SB, HMI fog, FS 5000, FS 7000 D, FS 7000 DL, FS 7000 DMT, 2018-08

To prevent fog building up on the HMI screens there is a new solution with dryer bags inside the cover.

Figure 2

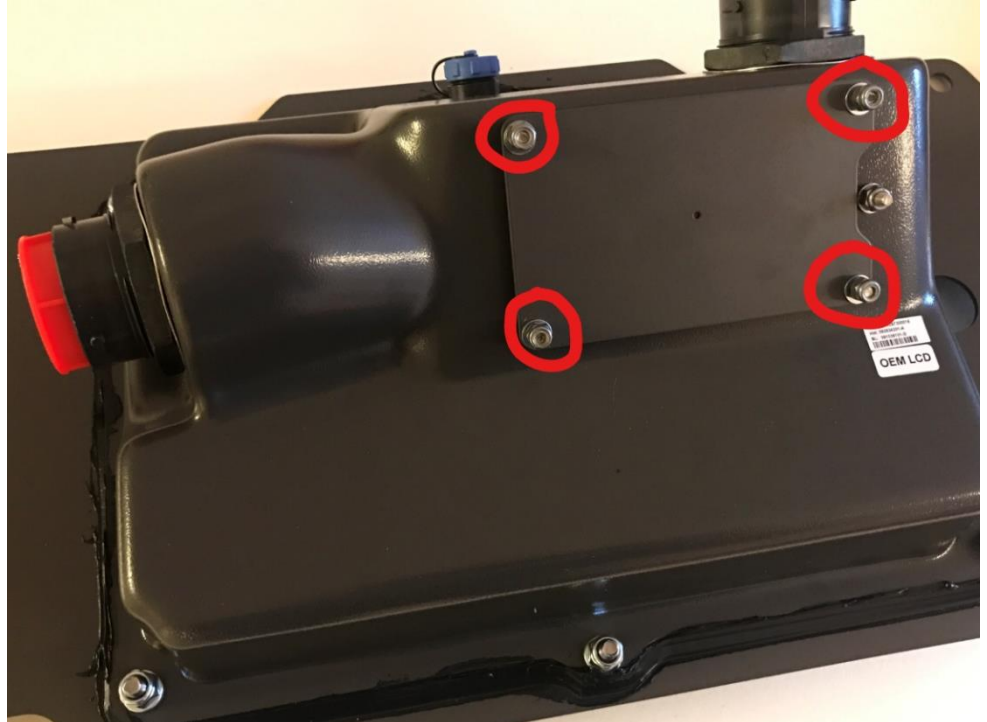
1. Remove cover on HMI back side, 4 nuts (fig 2).
